Access Compliance Report

Public Rights-of-Way

Intersection ID: 46317	Main Street: MAGNASCO_LN	Cross Street: BREWER_DR	Location:	E
ADA ID: 86A7B9C6CCBA	Ramp Type: Perp	Initial Pass/Fail: Fail	Overall Compliance: No	Severity Score: 8.75
Codes/Mitigation Info/Possible Solution		Field Measurements/Component Compliance

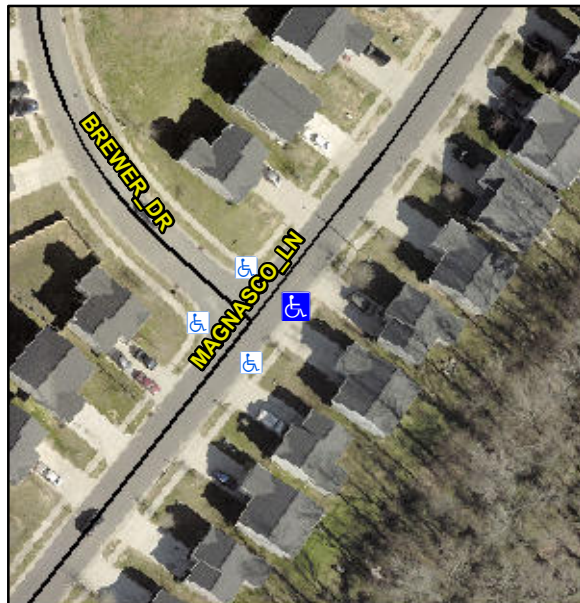
Not Found, R304.5.1

Compliance	Description	Data	Compliance	Description	Data
N/A	Ramp Length (in)	47.5	Yes	Ramp Slope (%)	5.5
No	Ramp Width (in)	47.5	Yes	Ramp XSlope (%)	0.5
N/A	Flare Type LT	N/A	N/A	Flare Type RT	N/A
N/A	Flare Slope LT (%)	N/A	N/A	Flare Slope RT (%)	N/A
N/A	Flare Traversable LT?	N/A	N/A	Flare Traversable RT?	N/A
N/A	Landing Length (in)	N/A	N/A	DWS Provided?	N/A
N/A	Landing Width (in)	N/A	N/A	DWS Contrast?	N/A
N/A	Landing Slope (%)	N/A	N/A	DWS Length (in)	N/A
N/A	Landing X Slope (%)	N/A	N/A	DWS Full Width?	N/A
N/A	Landing Curb? (Y/N)	N/A	N/A	DWS Offset (in)	N/A
N/A	Shared Landing?	N/A			
N/A	Gutter Ponding?	N/A	N/A	Gutter Slope (%)	N/A
N/A	Gutter Lip Ht (in)	N/A	N/A	Gutter X Slope (%)	N/A
N/A	Painted X Walk1?	No	N/A	Painted X Walk2?	N/A
	X Walk 1 Direction	To NW		X Walk 2 Direction	N/A
N/A	X Walk 1 Width (in)	N/A	N/A	X Walk 2 Width (in)	N/A
	X Walk 1 Slope (%)	5.5		X Walk 2 Slope (%)	N/A
	X Walk 1 X Slope (%)	0.8		X Walk 2 X Slope (%)	N/A

Remove & Replace Entire Ramp.
